SERVICE BULLETIN

PURPOSE : INFORMATION	ISSUE NO. : MSB-14E00-001	DATE : 2014-02-28
SUBJECT : INFORMATION ON 2015 MIRAGE/SPACE STAR WORKSHOP MANUAL(BODY REPAIR MANUAL)		<DESTINATION/MODEL> <M/Y> (EUR) 15 MIRAGE/SPACE STAR(A03A)
GROUP : GENERAL

This Service Bulletin contains the information about the 2015 MIRAGE/SPACE STAR WORKSHOP MANUAL(BODY REPAIR MANUAL).

SILENCER APPLICATION LOCATIONS

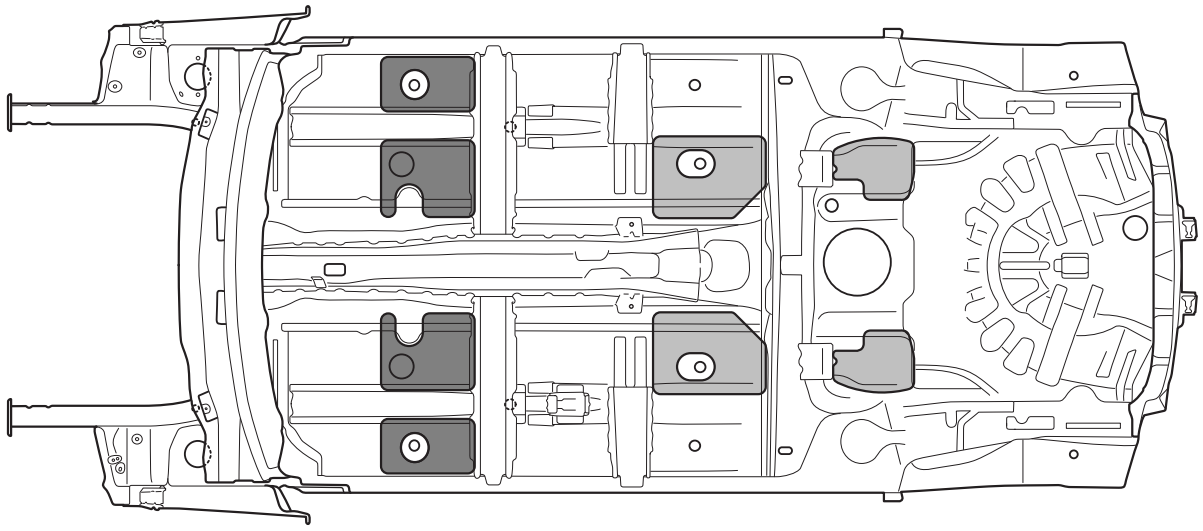
The section "SILENCER APPLICATION LOCATIONS" below has been established.

A silencer (melting sheet) has been affixed on the upper surface of the floor for vibration damping.

NOTE:
: 1.6 mm thick melting sheet (Place a melting sheet.)
: 3.2 mm thick damp sheet (Place two melting sheet one on top of another.)
( ) indicates the number of 1.6 mm melting sheets that are used for repair.
